EXHIBIT D
REGULATING PLAN

MIAMI 21 APPENDIX R: ECORESILIENCY SAP

AMENDMENTS TO MIAMI 21			
ORDINANCE	DATE APPROVED	DESCRIPTION	LEGISLATIVE ID
13973	2-25-2021	Special Area Plan for Jungle Island	8363
TBD	TBD	Amendment to ECORESILIENCY SAP (fka Jungle Island SAP) to allow for mixed use residential development and rezoning to T6-36 with a maximum height of 48 stories on T6 zoned parcel and new public park on CS zoned parcel.	TBD

**ILLUSTRATION 5.6 URBAN CORE TRANSECT ZONES
T6-36-A-O ZONING INFO.**

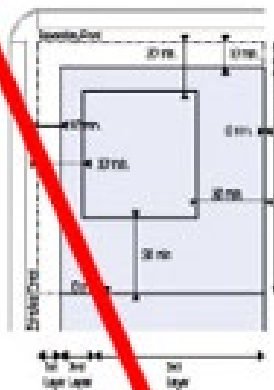
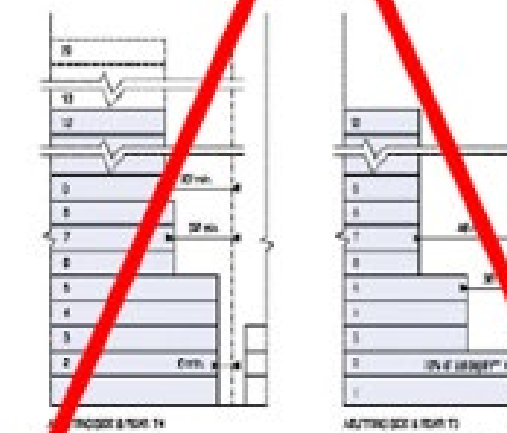
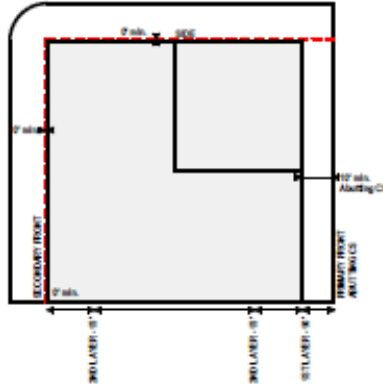
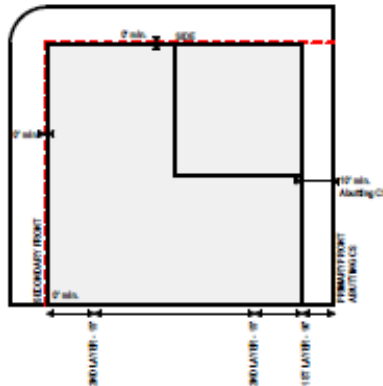
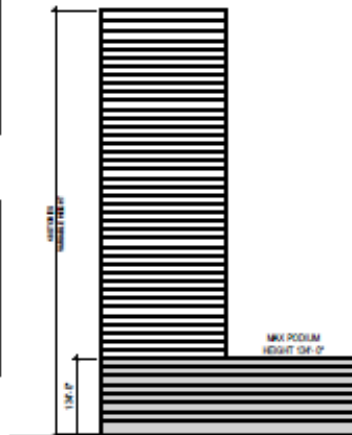
- b. ~~There shall be no maximum Lot Coverage by for any Building shall not exceed that, as shown in Illustration 5.6 of this Regulating Plan.~~
- c. Buildings shall be disposed in relation to the boundaries of their Lots according to Illustration 5.6 of this Regulating Plan.

- d. Buildings ~~may shall~~ have their ~~principal pedestrian entrances~~ Pedestrian Entrances on a Secondary Frontage as shown on the Jungle Island SAP Concept Plans.

- e. On Principal Frontage(s), for the minimum Height, Facades shall be placed in the Build-to Zone for a minimum of sixty percent (60%) of the length of the Principal Frontage as shown in Illustration 5.6 of this Regulating Plan. Where a portion of the Principal Frontage includes an Open Space Type, the length of the Principal Frontage shall be lined with Habitable Space or Rooms located directly behind such Open Space Type. In the absence of a Building along the remaining forty percent (40%) of the Principal Frontage Line in the event parking and services are proposed, a Streetscreen shall be built co-planar with the Façade. For the length of the Building Façade along a Principal Frontage, 100% shall be designed with Habitable Space or Rooms, unless a reduction is approved by SAP Permit.

- Compliance with the Design Review Criteria shown in Article 4 Table 12 of this Regulating Plan.
- g. Setbacks for Buildings shall be as shown in Illustration 5.6 of this Regulating Plan.
- h. Above the Podium, minimum Building spacing of sixty (60) feet is required.
- i. No cross Block-Passage is required.
- j. There is no maximum Lot size in the ~~Jungle Island~~ SAP.

BUILDING HEIGHT	
PRINCIPAL BUILDING	NO MIN.
OUTBUILDING	NO MIN.
HEIGHT ALLOWED	48 STORIES
